Project **IEEE 802.16 Broadband Wireless Access Working Group** <<http://ieee802.org/16>>

Title **Enhancement of Scanning and Association using SCAN-REQ/RSP**

Date Submitted **2004-07-08**

Abstract This document proposes the scheme enhancing scanning and association operation with SCAN-REQ/RSP

Figure E.2—Example BS advertisement and scanning (with association) by MSS request

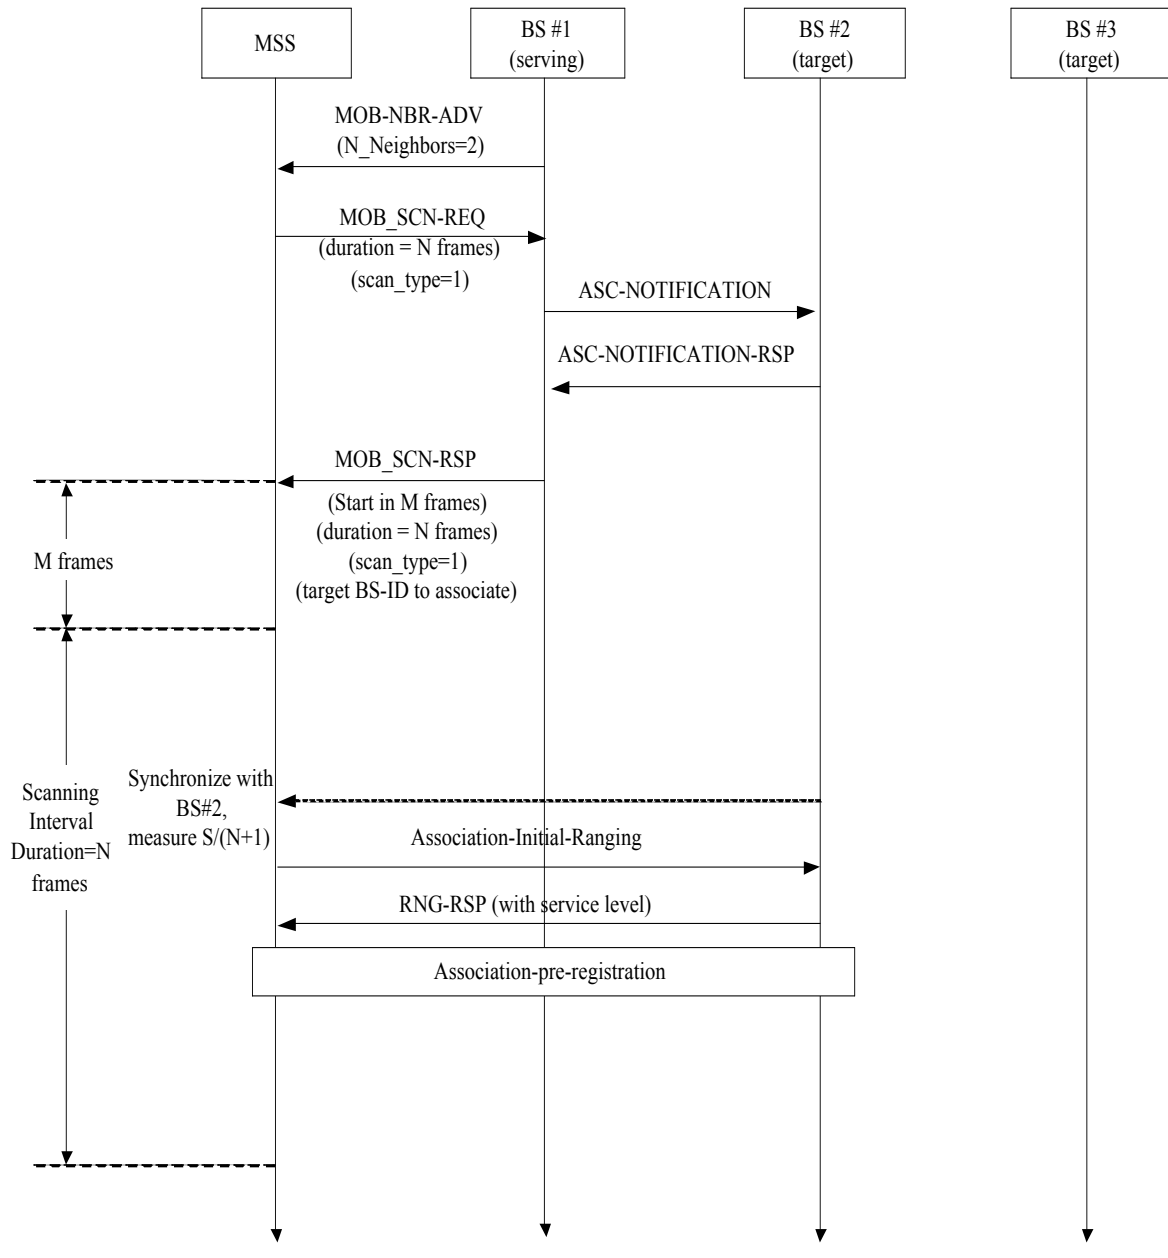
Association is an optional initial ranging parameter negotiation occurring during Initial Ranging of a BS. The function of association is to enable the MSS to record successful scanning and ranging attempts for the purpose of expediting a potential future hand-over of the MSS's active service flows to a target BS. An MSS may store successful ranging information of an associated BS for the purpose of setting initial ranging values in future ranging events. In order to perform association during scanning interval, a MSS may transmit MOB-SCN-REQ message to the Serving BS with Scan_Type field value '1'. A Target BS ID for association is added if the MSS already have selected one target BS based on neighbor information have gathered former scanning operation.

Upon reception of this message, the BS may request target BS to allocate invited ranging opportunity to MSS for association and receive response message from target BS. If Association is accepted, the Serving BS shall respond to the MSS with a MOB-SCN-RSP MAC Management message with Scan_Type=1 and neighbor BS ID that is requested by MSS or selected by the Serving BS.

Following reception of a MOB-SCN-RSP MAC Management message, an MSS shall try initial ranging to target BS that is recommended by target BS-ID in MOB-SCN-RSP message. The target BS may allocate invited ranging opportunity for the MSS.
